POLE	FUNC.	MAT'L	SIGNAL NO.	MAKE	NO. OF SECT.	SIZE	VISOR	B.P. OR LOUVERS	MOUNT	PED SIGNAL NO.	LEGEND	MESSAGE		MAKE	MOUNT
A	S	S	61	TCT	3S	8" RYG	T	—	SV-1	49	I	1S-IN	W/OR	ICC	SP
B	S	S	64	TCT	3S	12" RYG	T	B.P.	MAS	48	I	1S-IN	W/OR	ICC	SP
C	S	S	65	TCT	3S	8" RYG	T	—	TV-1	419	I	1S-IN	W/OR	ICC	SP
D	S	S	63	TCT	3S	8" RYG	T	—	TV-1	418	I	1S-IN	W/OR	ICC	SP
E	S	S	133	TCT	2S	12" LB	T	BP	TV-2	429	I	1S-IN	W/OR	ICC	SP
F	S	S	135	TCT	2S	12" LB	T	BP	TV-2	428	I	1S-IN	W/OR	ICC	SP
G	S	S	25	TCT	3S	3S12"	T	—	TV-1-T						
H	S	S	26	TCT	3S	3S12"	T	—	TV-1-T						
I	M	S	21	TCT	3S	3S12"	T	—	SV-1-T@11.5'						
J	M	S	24	TCT	3S	12" RYG	T	B.P.	MAS						
			137	TCT	2S	12" LB	T	BP	TV-2						
			131	TCT	2S	12" LB	T	BP	TV-2						
			165			3S8" bike	T		SV-2-TA@8'						
			156			3S8" bike	T		SV-2-TA@8'

CONTROLLER CABINET SIZE : M-cabinet BASE CABINET: _____

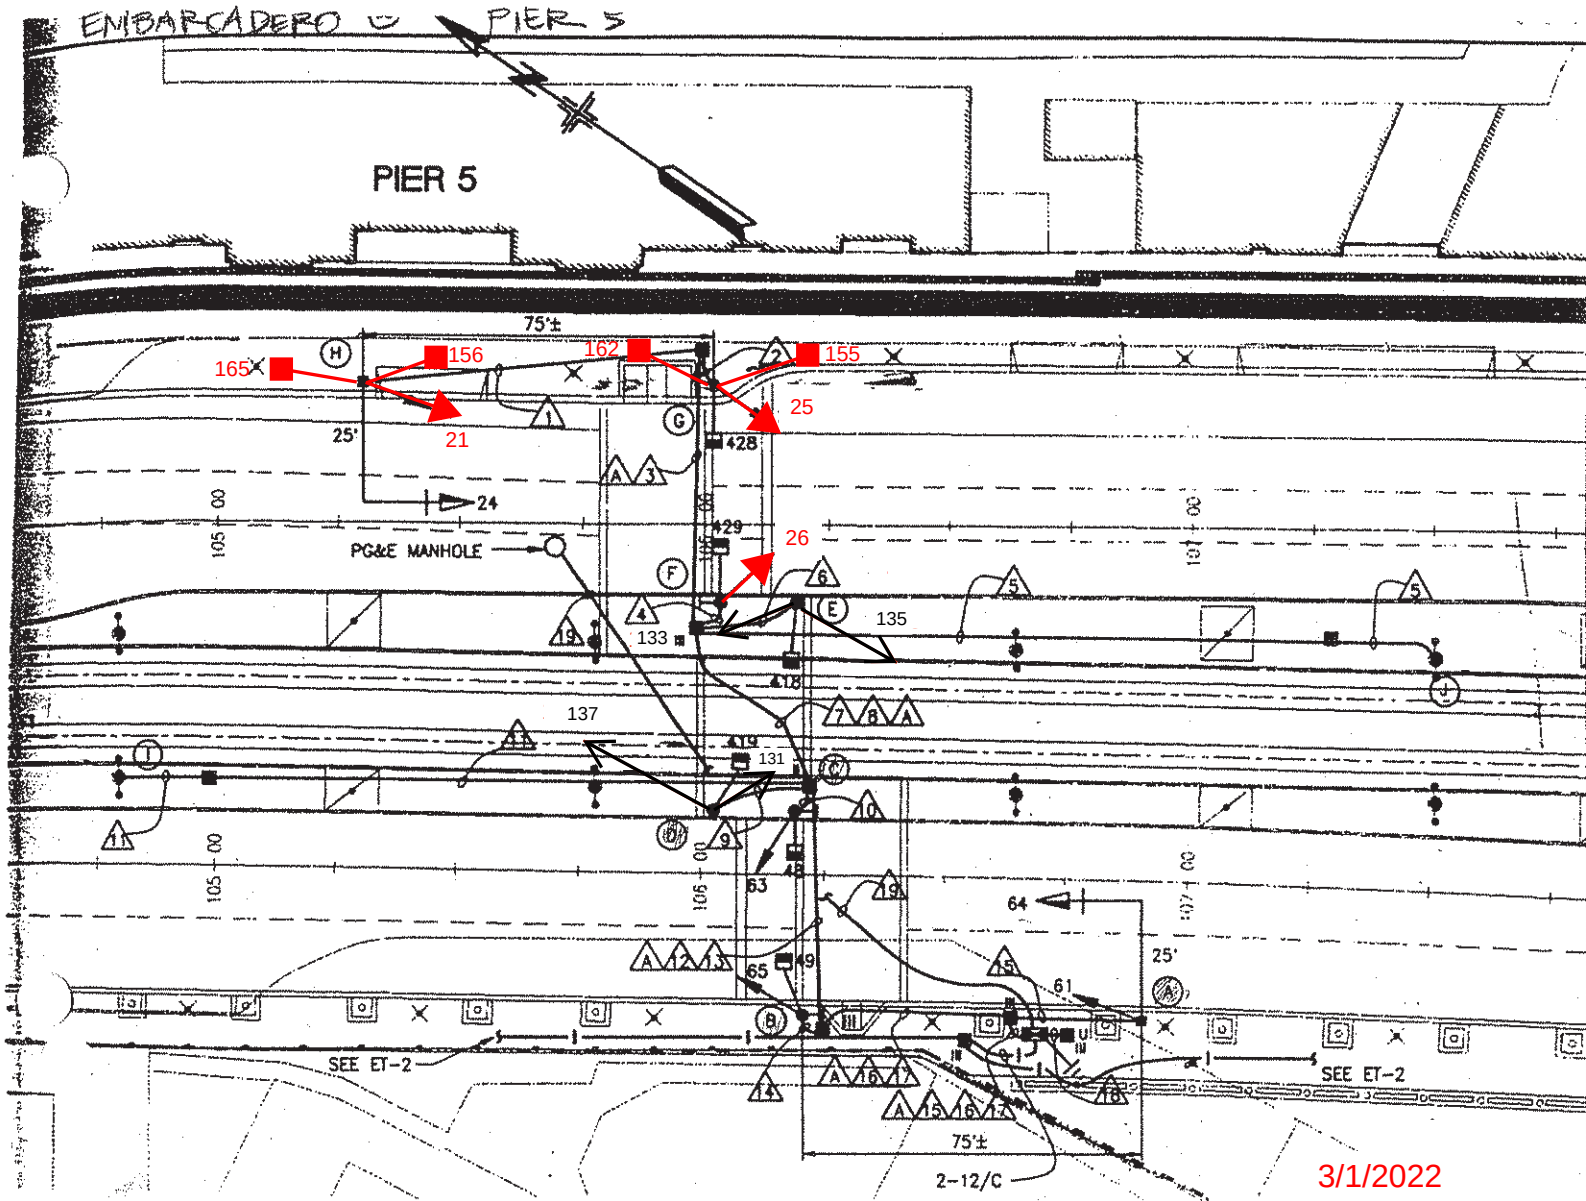
Add signals 155, 156, 162, 165. Update 21, 25, 26 to 3S12" per SRC 2021-300. - G. Ho

* Custom SV-2-T per figure below. 162 in Position A

SIGNAL NO.	MAKE	NO. OF SECT.	SIZE	VISOR	B.P. OR LOUVERS	MOUN'T
162		3	8"bike	T		SV-2-T*@8'
155		3	8"bike	T		SV-2-T*@8'
